From: Selim <Selim@sawayaeng.com>
Sent time: 09/16/2019 09:47:07 AM
To: Ron Dragoo
Cc: Jill Martin <jmartin@trumpnational.com>
Subject: RE: Tract 50666 - Sewer
Attachments: 2019-09-16 SS-S2 Tract 50666 - revised per City comments.pdf

From: Selim [<mailto:Selim@sawayaeng.com>]
Sent: Monday, September 09, 2019 1:30 PM
To: 'Ron Dragoo'
Cc: 'Jill Martin'
Subject: Tract 50666 - Sewer

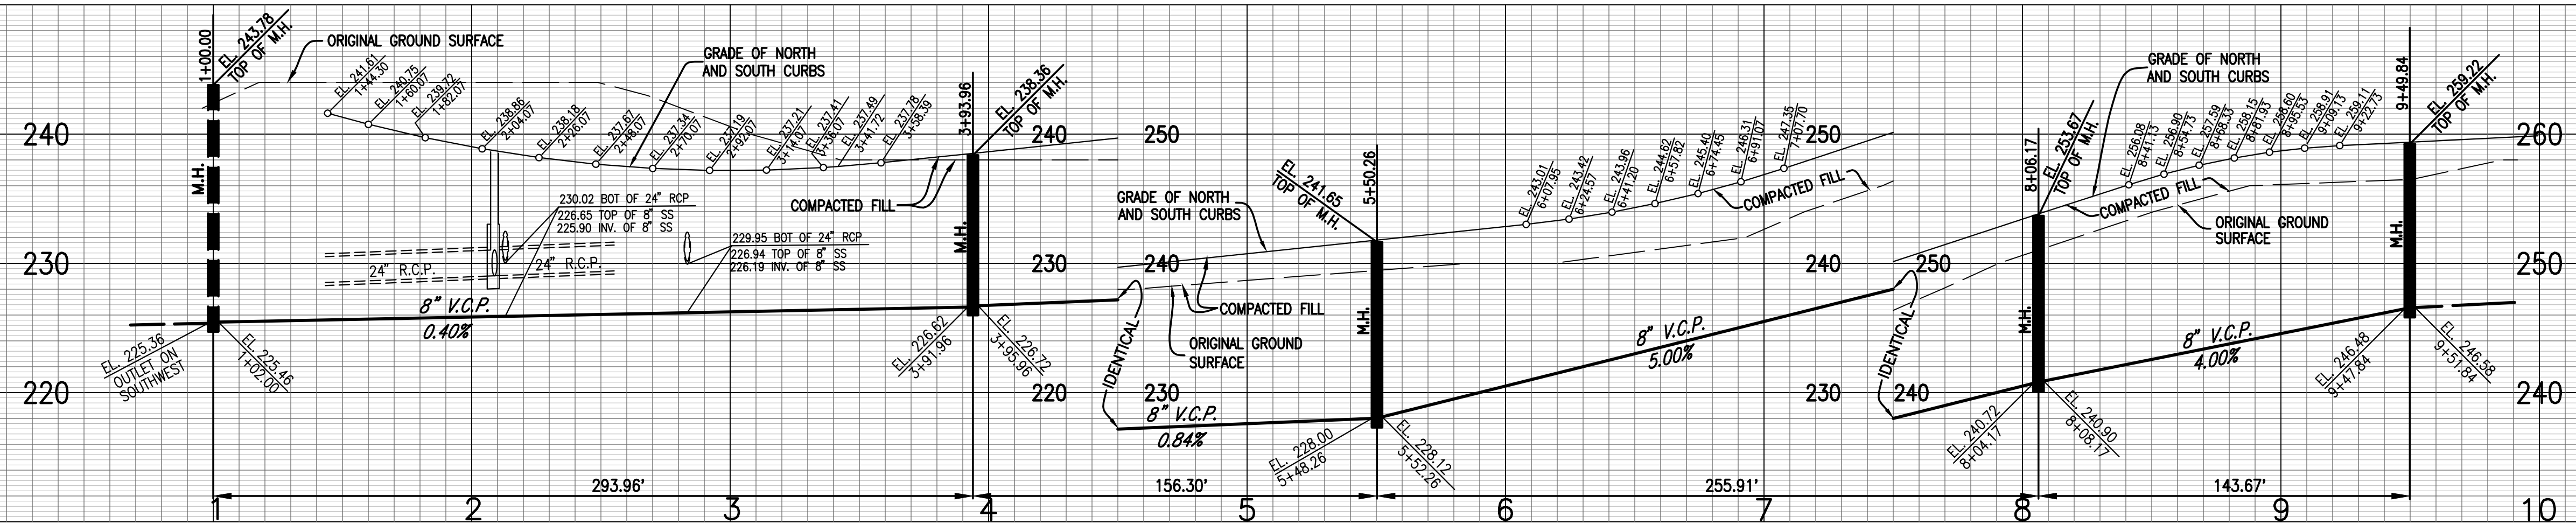
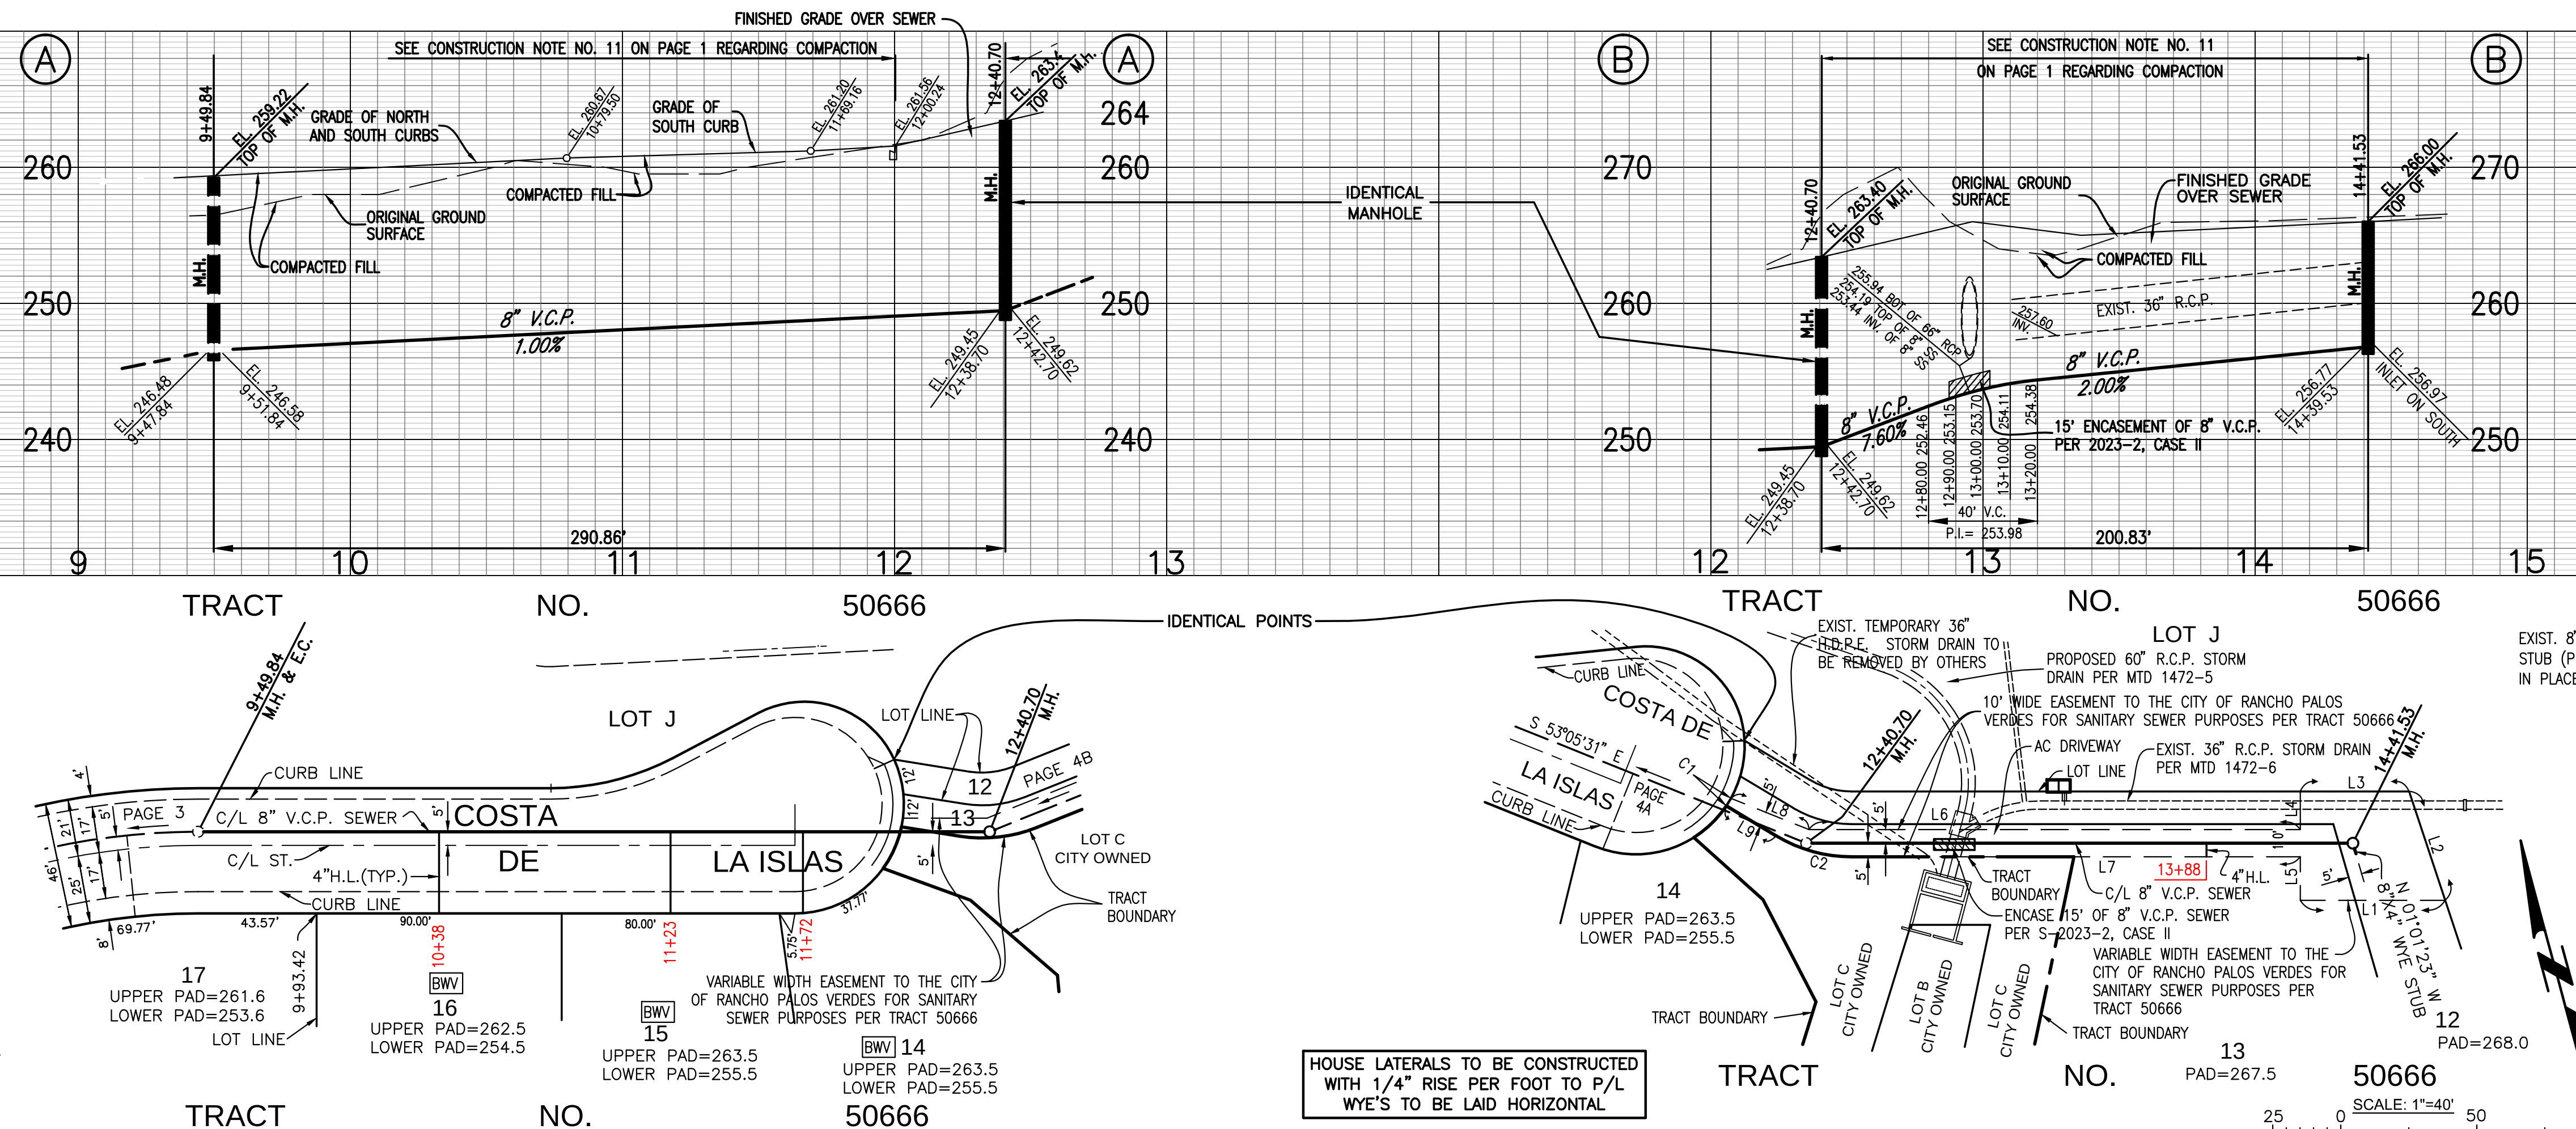
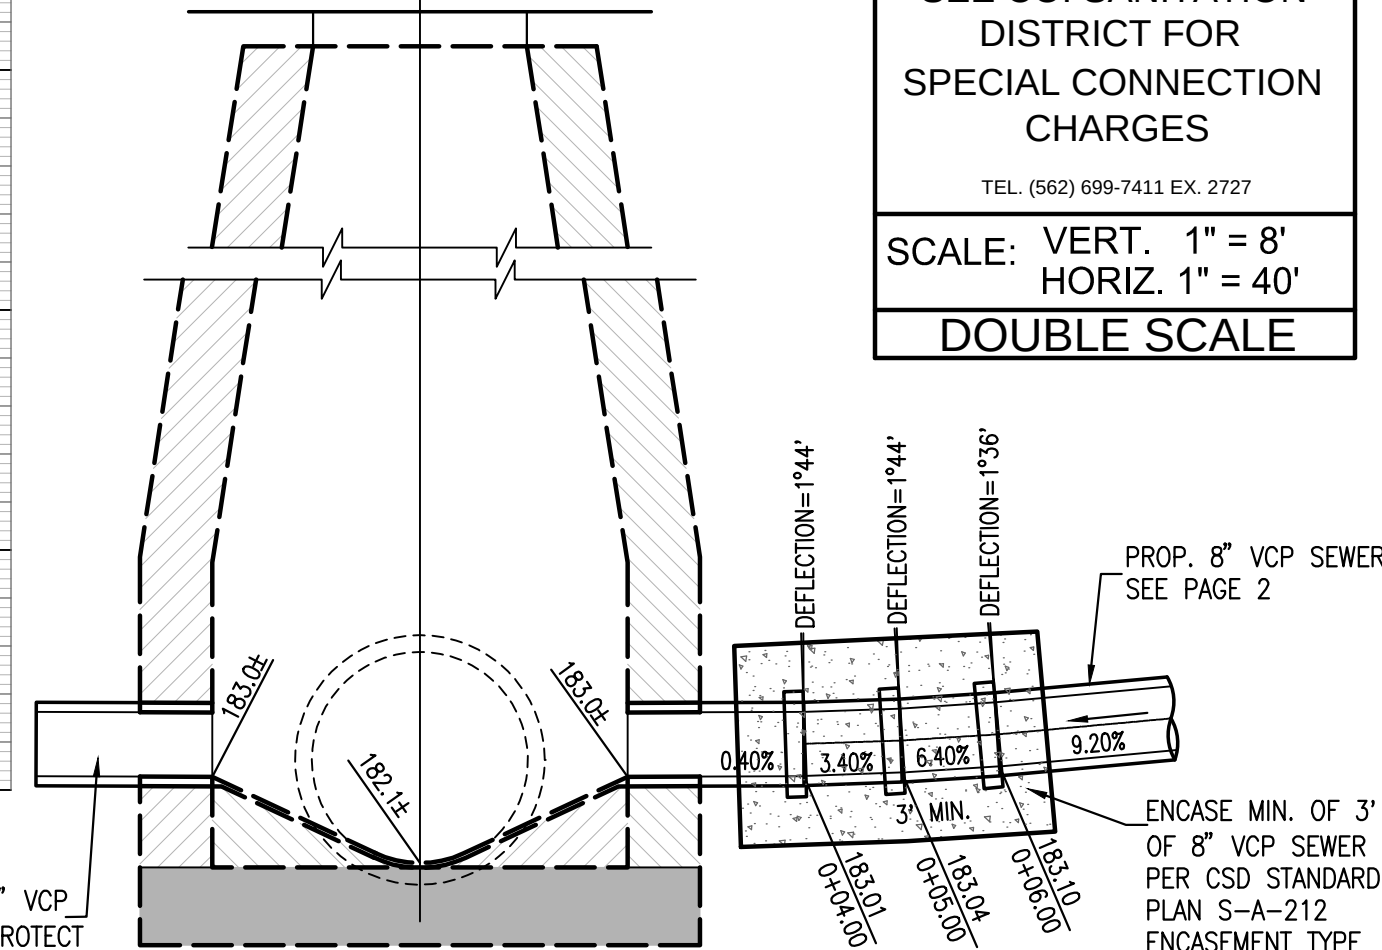
Showing the station of each lateral is preferred. Thanks.

Hi Selim, I just looked quickly at the mylars. I noticed there are no references as to where the laterals are to be in relation to the right of way. Can you give us the distance from the closest manhole to the location of each lateral and we can include this information on the plans please? Also, after the plans are signed by the Sanitation District, RPV needs a paper copy of the plans. Thank you.

Attached, please find the revised sewer sheet that shows the station of each lateral in red. The revisions would have to be drafted by hand since the plans are approved by the County. I can go to the City and do them tomorrow if you would prefer. Please let me know

I had the lateral stations on our first submittal which the County asked us to remove. When I had inquired, I was told that the County of Los Angeles standards to locate the laterals is to show at least 2 lotline stationing and the lot frontage dimension. The contractor would then be able to scale and determine the stationing of the wye and the 4" line.

- Do you want to show the distance from the downstream manhole or the station of each lateral? I recommend to show the station.
- Do you want to show the station (or distance) of the 4" lateral or the station of the Wye? I recommend to show the station of the 4" lateral
